FLORIDA POWER AND LIGHT COMPANY

TURKEY POINT UNIT 3 AND 4

**BORIC ACID CONCENTRATION
REDUCTION PROJECT**

TECHNICAL SPECIFICATIONS MARK-UP

Figure 3.1.2.5

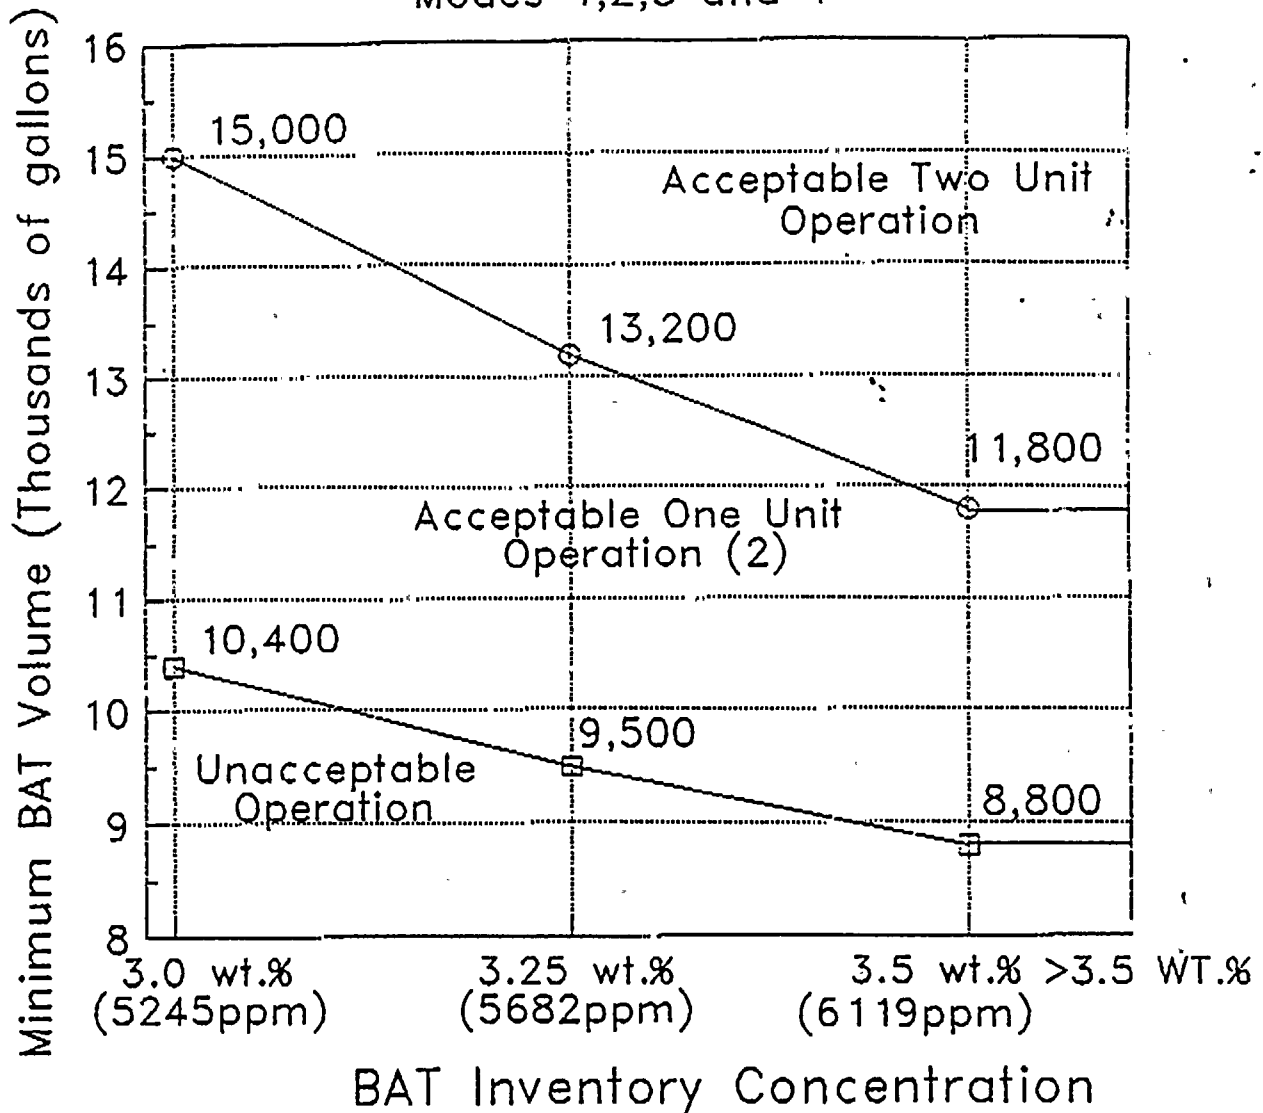
- 1) A minimum indicated borated water volume ~~of 3080 gallons,~~
- 2) A boron concentration ~~between 20,000 ppm and 22,500 ppm,~~ and
- 3) ~~A minimum solution temperature of 145°F.~~

in accordance with
Figure 3.1.2.5,

in accordance
with Figure
3.1.2.5,

A minimum boric acid tanks room
temperature of 55°F.

c. With the boric acid tank inventory concentration greater than 3.5 wt %, verify that the boric acid solution temperature for boration sources and flow paths is greater than the solubility limit for the concentration.
